Application for a Certificate of Public Convenience and Necessity (CPCN) for Approval of the Coastal Transmission System Transmission Integrity Management Capabilities Project (Application)

Response to the Commercial Energy Consumers Association of British Columbia (CEC) Information Request (IR) No. 1

1 22. Reference: Exhibit B-1, page 40

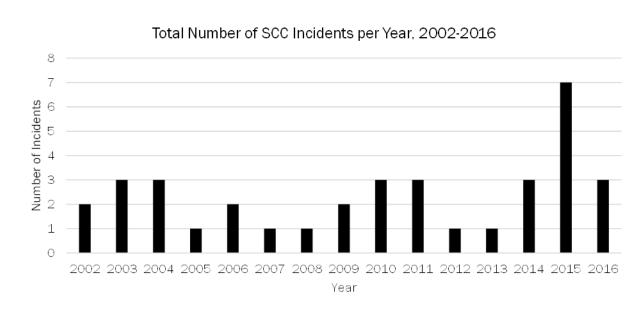
- Approximately half of reported PHMSA SCC incidents through 2002-2016 occurred at 60
 percent of SMYS or lower; and
- Approximately one quarter of reported incidents occurred at 55 percent of SMYS or lower, with some circumferential SCC leaks occurring below 30 percent of SMYS (in presence of additional loading factors).
- 22.1 Please provide a chart depicting the total number of incidents in each year between 2002 and 2016.
- 4 5

- 6 Response:
- 7 JANA provides the following response:
- 8 The total number of SCC incidents reported in the PHMSA dataset between 2002 and 2016 are
- 9 shown in the figure below.

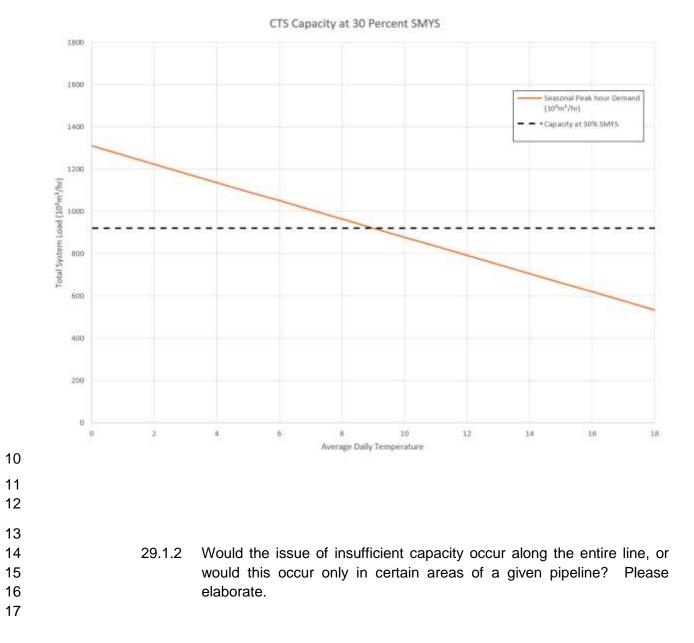
29.1.1 Please provide FEI's demand curve, and provide the point at which FEI would not be able to meet the current peak demand.

2 To achieve an operating stress less than 30 percent of SYMS, FEI would require the system to 3 operate at a pressure of 2390 kPa. FEI's analysis of the CTS during the development of the 4 TIMC CTS Application demonstrated that the capacity of the system under this condition is 5 exceeded when the average daily temperature is between 9 degrees Celsius or cooler. Daily 6 temperature averages lower than 9 degrees Celsius could occur any time in the period of 7 September through May. The figure below shows the system demand versus temperature 8 indicating the demand at which the CTS would have insufficient capacity if it were regulated to 9 30 percent of SMYS.

SCC Management Post EMAT ILI Run

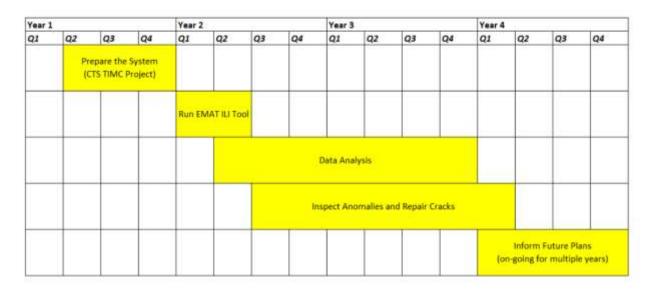
- 2. Run the Tools
- 3. Analyze the Data
- 4. Inspect Anomalies and Repair Cracks
- 5. Inform Future Plans
- 2
- Please provide timelines for each of the identified activities. 33.1
- 3 4
- 5 **Response:**

- 11 5. Inform Future Plans: Including blind spot repairs, determination of EMAT ILI re-12 inspection interval, and the assessment of pipeline integrity data to determine areas 13 requiring broader mitigation efforts.
